Responses to Inquiries received from Potential Vendors
IFB No. 17087R/DG – Procurement of Cast Iron Main Drains:

IFB No. FQ17087R/DG

Amendment A002

DETAIL

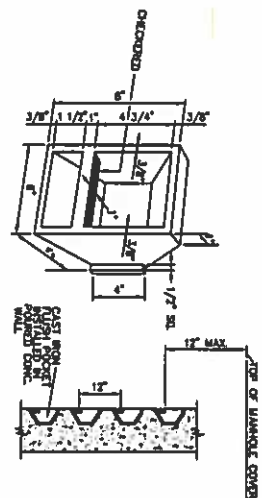
6. Maximum load capacity of the drain grate: Please clarify the maximum load requirement and the location of the grates on the tracks.

Response: Grates in the track bed between the rails are specified as "PER ASTM A48 CLASS 35" – which will provide the proper loading. (Drawing DD-M-149 attached)
